UNITED STATES PATENT AND TRADEMARK OFFICE

Office Action Summary	Application No.	Applicant(s)
	10/517,055	BOUGAMONT ET AL.
	Examiner	Art Unit
	Jason J. Boeckmann	3752

DETAILED ACTION

Examiners Marked up Figure 1

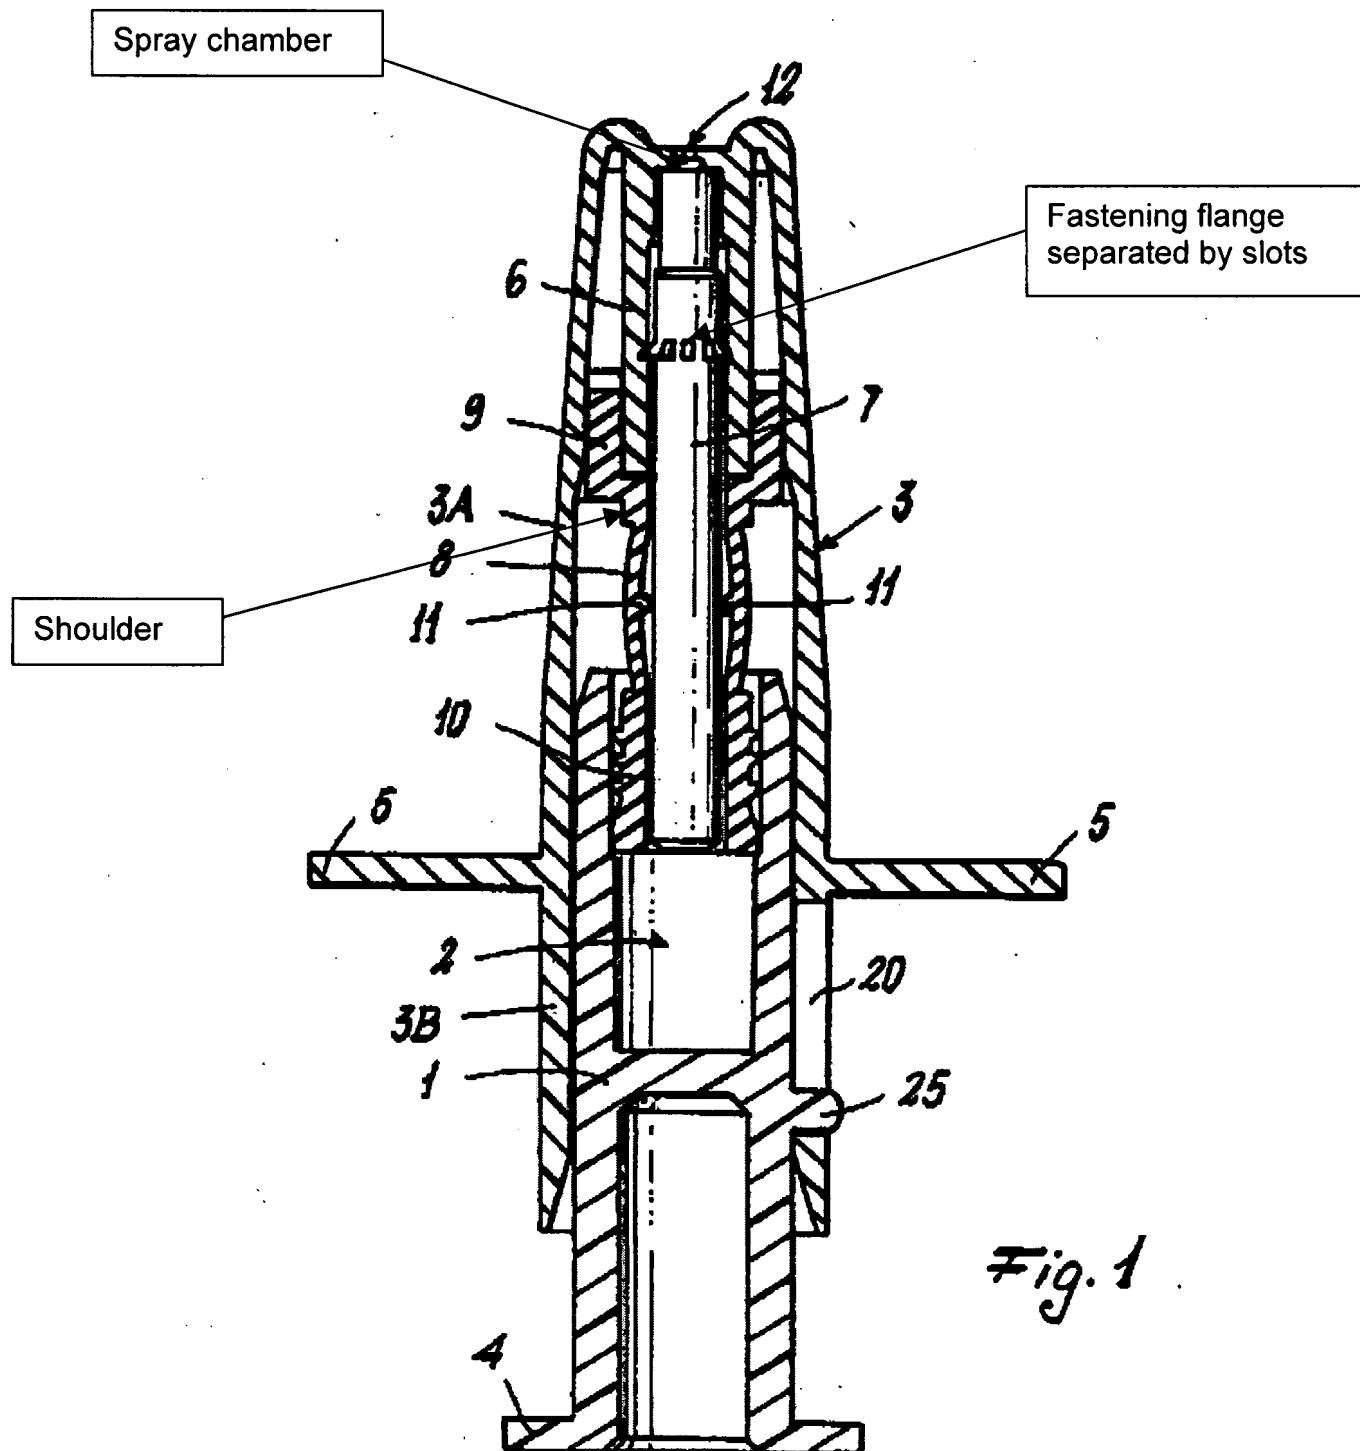
Marelli shows a an end piece for spraying a product comprising a cylindrical body (3) having an axial channel (6, 8, 9, 10) whose first end (upper end) is delimited by a transverse wall exhibiting a spray orifice (12) and who's second end (lower end) is capable of communicating with a reservoir, the end piece further comprising an axial core (7) disposed in the channel, whose first end (upper end) is situated facing the transverse wall and defines with the latter a spray chamber (see examiners marked up figure 1 below), a communicating passage between the second end of the spray chamber being formed between the core and the wall of the channel, wherein the core comprises a fastening flange (see examiners marked up figure 1 below) having a fastening edge which is directed towards the second end of the core and which cooperates with the wall of the channel to retain the core in the channel, wherein the core comprises, at its second end, an end portion of reduced diameter (the section of the core 7 that is of a smaller diameter than the outer diameter of the fastening flanges, see examiners marked up figure) around which an annular space (the space around core 7 in the vicinity of member 8) is defined in the channel, the reduced diameter be constant along at least a portion of the end portion.

Regarding claim 2, the fastening flange comprises at least one annular flange sector delimited by a slot (see examiners marked up figure 1 below).

Regarding claim 3, as best understood, and claim 16, the channel has a fastening portion with which the flange cooperates and over which the diametral dimensions of the channel are less than the diametral dimensions of the flange, and an insertion portion (8) which extends between the fastening portion and the second end of

the channel and over which the diametral dimensions of the channel are at least substantially equal to those of the flange.

Regarding claims 4, 5, and 17-20, the axial core comprises an axial bearing surface (the outer surface) cooperating with the wall of the channel and at least one radially projecting cylinder sector delimited by a slot (see examiners marked up figure 1 below)

Regarding claims 10, the core, at its second end, comprises an end portion of a reduced diameter that is beveled (figure 1).

Regarding claim 11, the channel comprises a shoulder (see examiners marked up figure 1 below) in the vicinity of the second end of the channel and the core extends towards the second end of the channel beyond the shoulder.

Regarding claim 12, the end piece includes a tubular rod (1) providing a connection to a reservoir, wherein the second end of the channel is plugged together with the tubular rod and the second end of the core is engaged in the rod (figure 1).
